Oklahoma Gas & Electric 2024 Draft Integrated Resource Plan: Sierra Club Comments¹

Sierra Club provides the following comments on Oklahoma Gas and Electric’s (OG&E or the Company) 2024 Draft Integrated Resource Plan (IRP). OG&E has failed to sufficiently evaluate the retirement of Muskogee Unit 6 and Sooner Units 1 and 2 to ensure that Oklahoma customers are not burdened with propping up uneconomic units. In fact, despite having the capability to do so, OG&E has failed to optimize for economic retirement of these units or even to simulate multiple retirement dates outside a single case. Further, in that one case, OG&E’s own modeling shows that conversion of Muskogee Unit 6 and Sooner Units 1 and 2 to gas rather than coal is the least costly option to comply with the federal Good Neighbor Plan—as opposed to installing expensive emission controls or replacing with new gas generators. Moreover, OG&E has failed to fully reckon with risk of environmental compliance costs at Muskogee 6 and Sooner 1 and 2, particularly by failing to account for the new proposed rule pursuant to Clean Air Act Section 111(d). Finally, OG&E has overstated the cost of replacement solar, wind, and battery res

Figure 1: Capacity Factor of OG&E’s Coal Units (%)

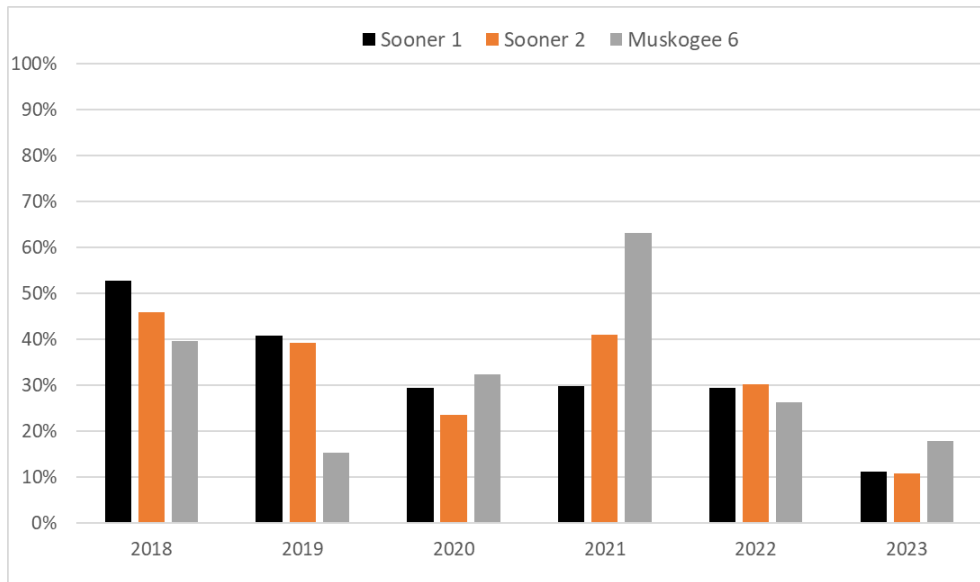
The capacity factor, which is a measure of how much of the units' maximum generation is used, is indicative of how economic the units are because SPP decides to commit and dispatch the units to minimize the costs in the RTO. As shown below in Figure 1, the units have run infrequently in recent years: each of the three coal units has operated, on average, less than one third of the time since 2018. In 2023, all three units operated at a capacity factor below 20 percent. Most recently, the units were effectively operating as peaking plants. In 2023, the Sooner units did not operate at all during the months of March, April or December.⁴

For coal units with high fixed operating costs, this low level of operation is not economically sustainable and should be a wake-up call for a resource planner. If the units are not operating, that means either they are on an unplanned outage, they are on a planned outage, or they are uneconomic to operate in SPP. Moreover, as the units increase in age, they are likely to face increasing reliability issues and higher maintenance costs. Even absent impending regulatory compliance needs, these coal units should be assessed for retirement far earlier than OG&E’s current plans—including by or before 2030. The Company has the ability to conduct such an analysis with the tools at hand. We are pleased to see that OG&E is using Encompass for capacity expansion modeling in this IRP, but the model is not being deployed with its full capability. Capacity expansion modeling is a meaningful tool to evaluate new supply options and a tool for evaluating retirement options for existing resources. The Company could and should let the model decide on economically optimal retirement dates, a key feature of Encompass. At the bare minimum, it could and should test multiple retirement options at its coal units. Thus, existing and new resources can compete with one another to arrive at a cost-optimal portfolio. Otherwise, foreclosing the retirement options in the modeling, as OG&E has done, also forecloses the possibility of that lower-cost plan.
